From: Zoning
Sent: October 1, 2021 4:31 PM
To: Samantha Cole
Subject: FW: Response to REZ No. 00759 -557 Simcoe - resubmission comments of May 3, 2021 plans
Attachments: 557 Simcoe St bubbled 3rd version.pdf; 557 Simcoe 3rd response.pdf

From: Chelsea Medd <cmedd@victoria.ca>
Date: July 8, 2021 at 4:24:55 PM PDT
To: The Mark Imhoff Group <info@homesalesvictoria.com>
Cc: Laura Nixon <l.nixon@hotmail.com>
Subject: REZ No. 00759 - 557 Simcoe - resubmission comments of May 3, 2021 plans

Thank you for your submission on May 6, 2021. Apologies for the delay in response as staff reviewed the application. Thank you Mark for the call yesterday to discuss our Planning comments. As a summary, I've reviewed with my Assistant Director, and we still have concerns with the building forms, site planning, and prominence of the driveway access on the site and street frontage. Staff would strongly recommend a single building, which would be a better contextual fit and reduce the impacts of the driveway and parking. We are unsure at this time the Planning recommendation when this goes to Committee of the Whole. Please let us your openness to making the revisions if the design (2 buildings with two un

- ① 1.75m curbside sidewalk and 0.15m curb
- ② 2.0m planted boulevard
- ③ Combined 1.2m entrance pathway

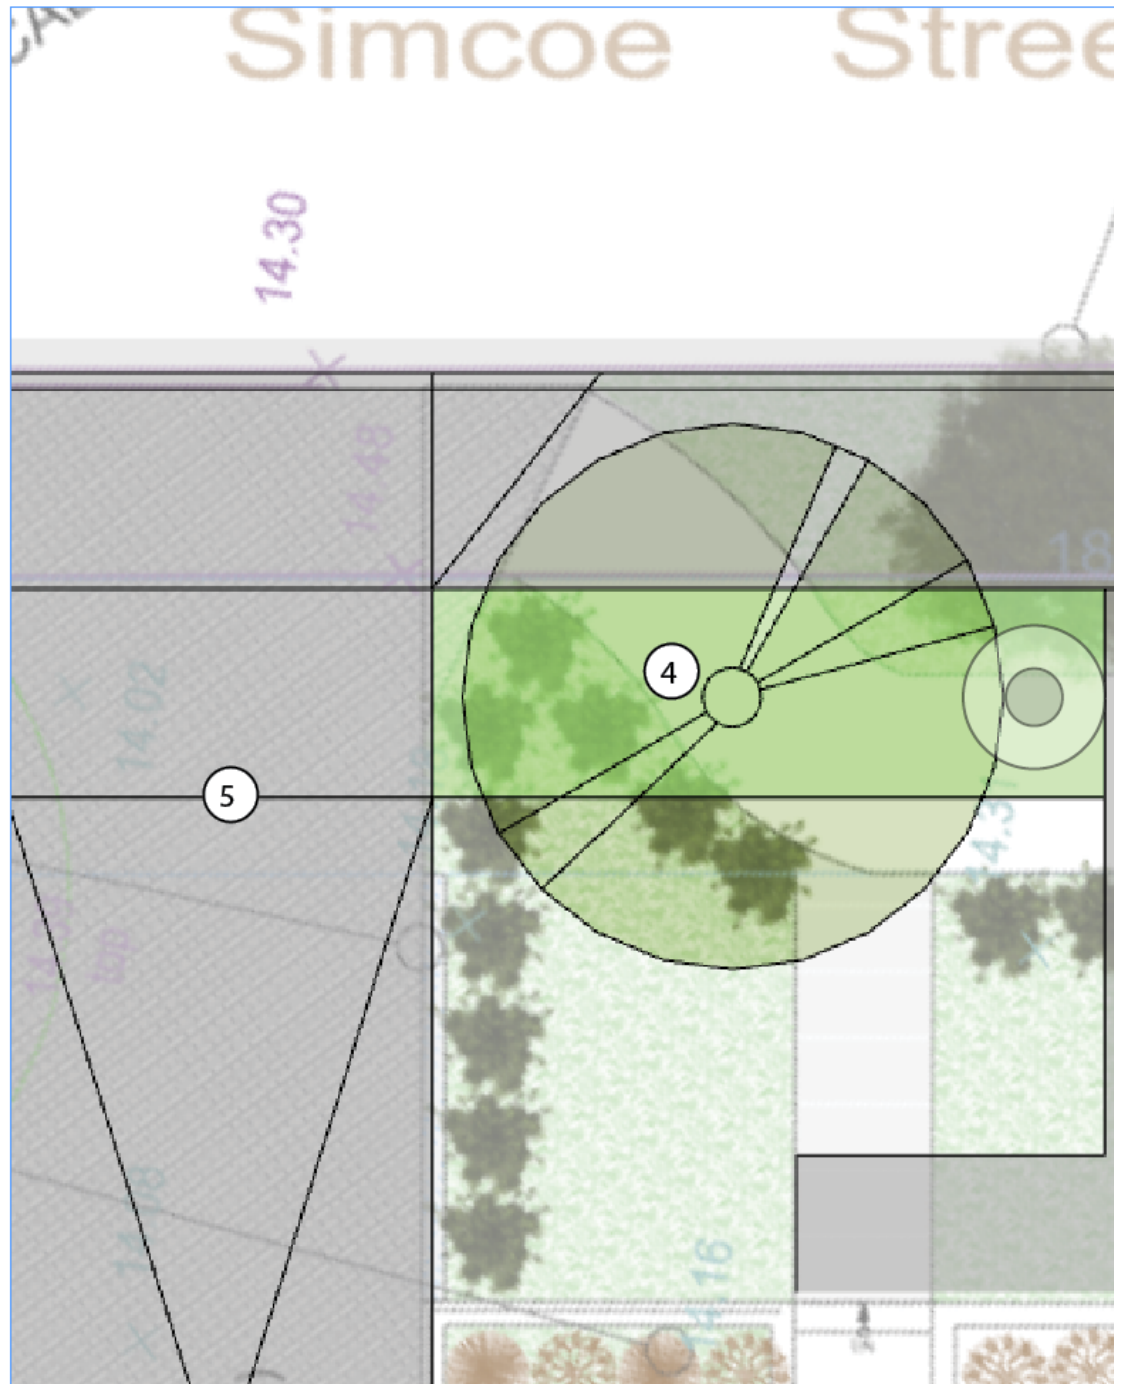
In the Application Review Summary dated January 26th, 2021, staff had requested an in-bound sidewalk along the internal Statutory Right of Way (SRW) boundary to meet Council approved objectives related to enhanced facilities for pedestrians and urban forestry. Given the revised application with a smaller frontage, in-bounding for this smaller section is not practical, as both the tree spacing and sidewalk transition are tighter than City standards. Please incorporate a revised plan that includes a 1.75 metre curbside sidewalk (plus 0.15m curb) and a 2.0 metre boulevard with two trees in the SRW at 8.0 metre spacing. One shared pathway crossing the boulevard in the SRW is supported between the trees. The SRW can be reduced from 2.6 metres to **2.0 metres. See attached conceptual sketch.** Please revise the next plan submission accordingly.
AGREED SEE A002 AND A103
